# CITY OF PORTLAND, MAINE

Project Name: Medical and General Office Building  
Project ID: 2016-075  
Address: 1945 Congress Street CBL: 216-A-6  
Applicant: Northland Enterprises, LLC  
Planner: Nell Donaldson

# PLANNING BOARD REPORT PORTLAND, MAINE

Medical and General Office Development  
1945 Congress Street  
Level III Site Plan and Subdivision Review  
2016-075  
Northland Enterprises, LLC, Applicant  
CBLs: 216-A-6, 217-A-1

Figures 2 and 3: 1945 Congress Street, existing zoning (top) and final site plan (bottom)

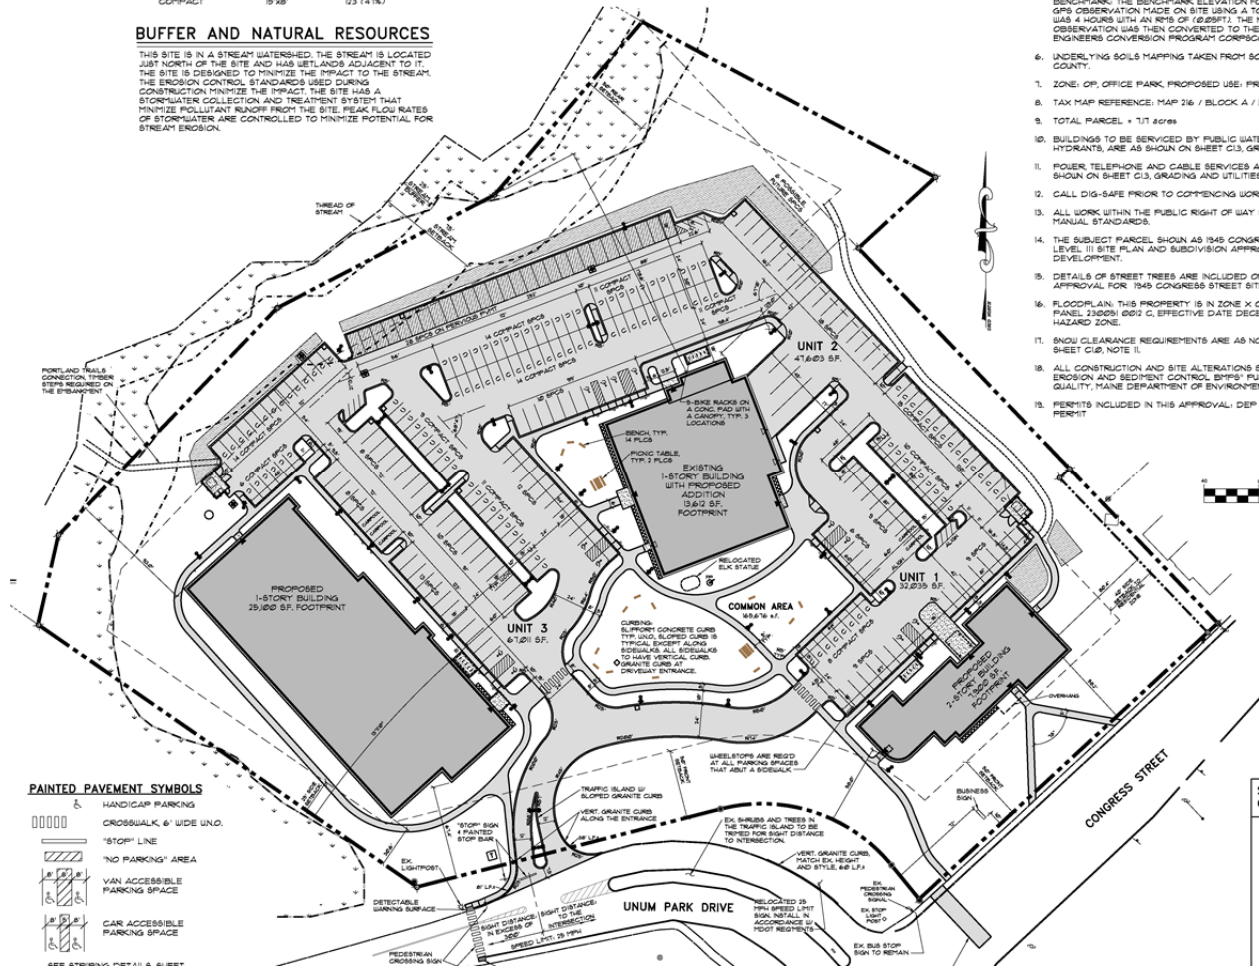
The site plan shows one point of vehicular access from UNUM Park Drive, approximately 250 feet from its intersection with Congress Street. From this driveway, the vehicular network encircles the Elks building and provides access to parking spaces that line the vehicular ways on both sides.

Pedestrian access is proposed via two oblique walkways from the existing sidewalk on Congress Street to the medical office building and from Congress Street to the center of the site. The plans also show a sidewalk connection directly from the existing walkway on the south side of UNUM Park Drive to the Clark Insurance building. Mr. Errico has reviewed the sidewalk plan and writes,

*The applicant has provided a sidewalk and crosswalk connection to UNUM Drive. Additional details will be required for the design and construction of the handicap ramps. Warning signs should also be provided. I would note that the location of the proposed crosswalk is at the termination of the existing vertical curbing. I need to further review this to determine if this location is acceptable. It may make sense to locate the crosswalk closer to the driveway for a more direct pedestrian routing and with this change provision of a smaller radius (few vehicles would be expected to turn right into UNUM). A condition of approval shall note that specific design details for the ramps, including exact location of crosswalk, shall be provided for review and approval by City staff.*

2. The applicant shall provide design details for the ramps and crosswalk proposed across UNUM Park Drive for review and approval by the Department of Public Works;
